# Major Projects Group - Document Submittal Coversheet

Date 09/17/04 Project Name South Waterfront Permit # 03-123594

**BES PLAN EXAMINATION CHECK SHEET**

Street Address:	<b>3510 SW BOND AVE</b>
Description of Work	<b>REVISED ELEVATIONS, GRADING, EROSION &amp; STORM FOR SOUTH WATERFRONT -SEE COMMENTS RE: TIMELINE FOR ISSUANCE</b>

Block 37 Stability Analysis for Temporary Stockpile Above Riverbank  
w/ Slopes of (2.0H:1V)  
 $K_h = 0.00$

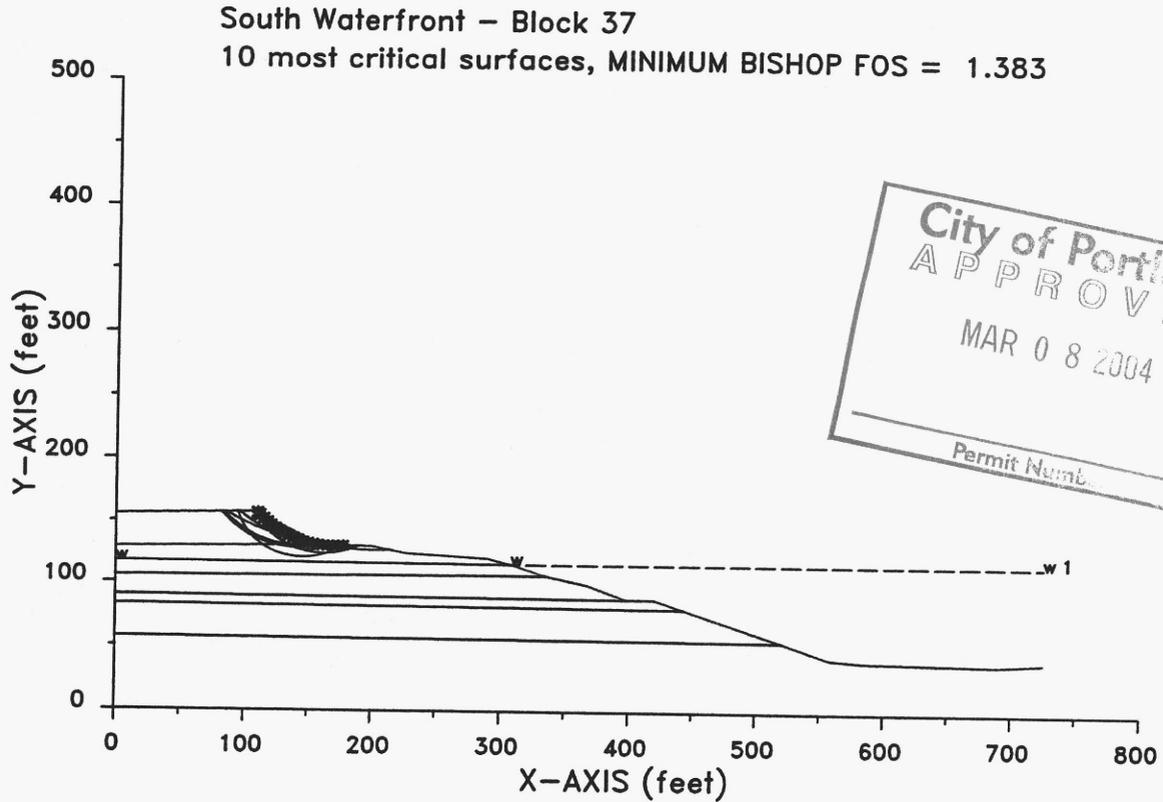
As requested, we have performed a slope stability analyses for the temporary stockpile located on Block 37B near the west bank of the Willamette River. Slope stability was evaluated using XSTABL Version 4.1 and Bishop's simplified method of slices. The analysis shows a safety factor of at least 1.3 against slope failure. The critical failure surface is through fill embankment and existing site soils. The fill embankment geometry was selected based on Otak's December 5, 2003 construction plans that show a maximum embankment height of 25 feet. We have attached the results of our analysis for your review.

In our opinion, site conditions provide an adequate margin of safety against slope failure for the proposed temporary fill embankment. If the embankment geometry deviates significantly from that shown in the plans, additional slope stability analyses will be necessary.

Block 25/29 Stability Analysis for Temporary Slope Cuts (1.5H:1V)  
 Eastern Excavation Side  
 Kh = 0.00

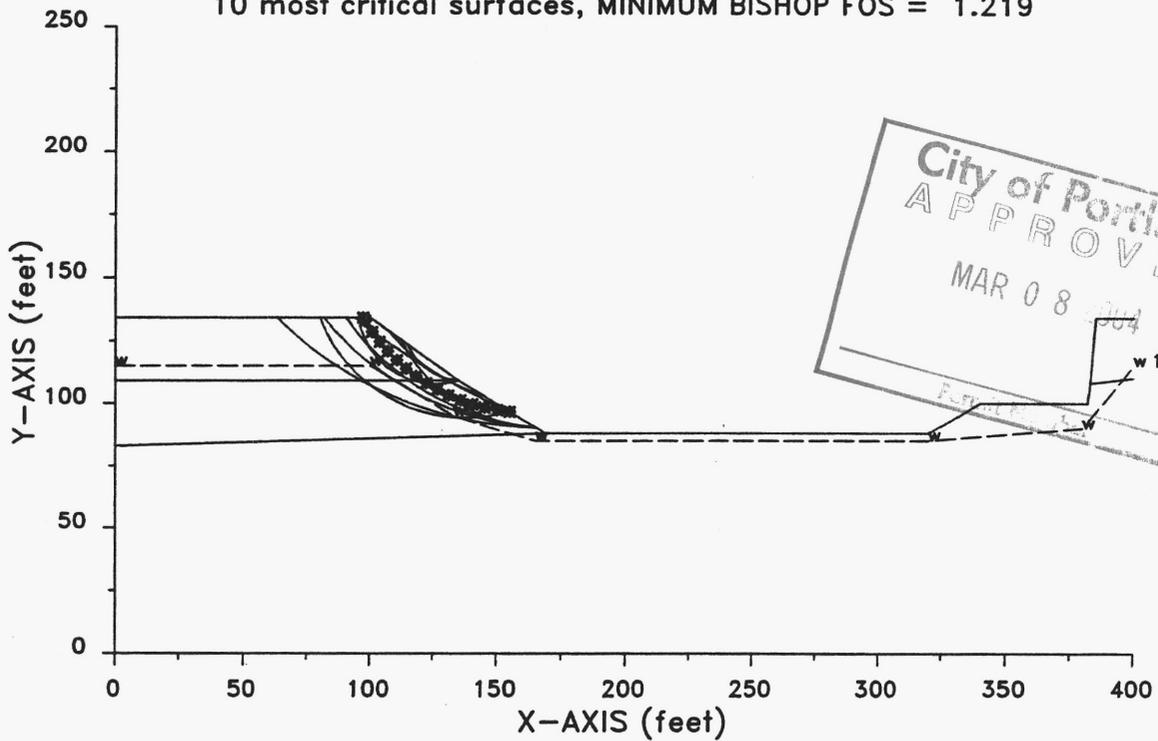
We performed a stability analysis for the temporary cut slope on the east side of the proposed excavation of Block 25/29. The analysis was performed as described in our response to Checksheet Item 1. Our analysis shows a safety factor of at least 1.2 against slope failure during the temporary

cut condition. Our analysis assumes that the cut slope is dewatered and is at an inclination of 1.5 horizontal 1 vertical or flatter. In our opinion, site conditions provide an adequate margin of safety against slope failure for the temporary cut. The results of our slope stability analysis are attached for your review.
